DECISION, CONDITIONS, FINDINGS OF FACT AND CONCLUSIONARY FINDINGS OF THE MCMINNVILLE HISTORIC LANDMARKS COMMITTEE FOR THE APPROVAL TO CHANGE THE APPROVED EXTERIOR BUILDING MATERIAL FROM STUCCO TO PAINTED CEMENTITIOUS PANELS WITH REVEAL JOINTS OF A NEW BUILDING AT 631 NE 1ST STREET WITHIN THE DOWNTOWN DESIGN AREA

- DOCKET:** AMENDED DDR 1-21 (Downtown Design Review for New Construction)
- REQUEST:** Approval of a Downtown Design Review application to change the approved exterior building material from traditional stucco to painted cementitious panels with reveal joints for the construction of a new building at 631 NE 1st Street on a parcel that is currently vacant and approve proposed exterior building colors. The proposal includes a request for a waiver to allow cementitious panels as building material.

Figure 3. South (Front) and North (Rear) Facing Elevations Rendering

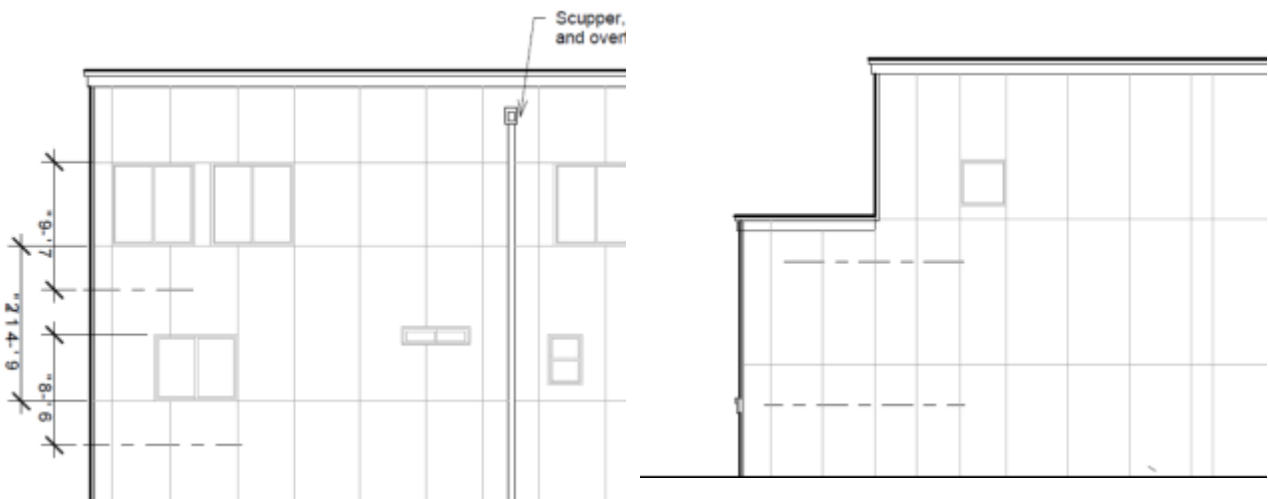
The HLC believes that the proposed cementitious panels are similar in appearance to stucco, which is an approved material in the downtown design overlay, but had concerns about the system’s reveal joints between the panels. The committee elected to allow the reveal joints as proposed on the non-public facing facades, but required that the public-facing façade (1st Street façade) be required to use flangeless joints on the vertical sides of the panels where the system allows.

The third story of the First Street is recessed back from the front façade of the first two stories. This is to accommodate a private patio area for the residential use. Since it will not be as visible from the street, the third story of the First Street façade can be treated in the same manner as the non-public facades.

The first two story of the building is more prominent and visual to the public. Having flangeless vertical reveal joint trim would be similar to stucco joint, Therefore, a condition is necessary.

Conditions for Finding: The vertical reveal joint trim of the painted cementitious panels of the first two stories of the southside of the building (First Street) shall be flangeless

Outside corner details of the painted cementitious panels and reveal joint trim shall be submitted for approval by staff and Historic Landmarks Committee Chair prior to installation of panels and joint trim.
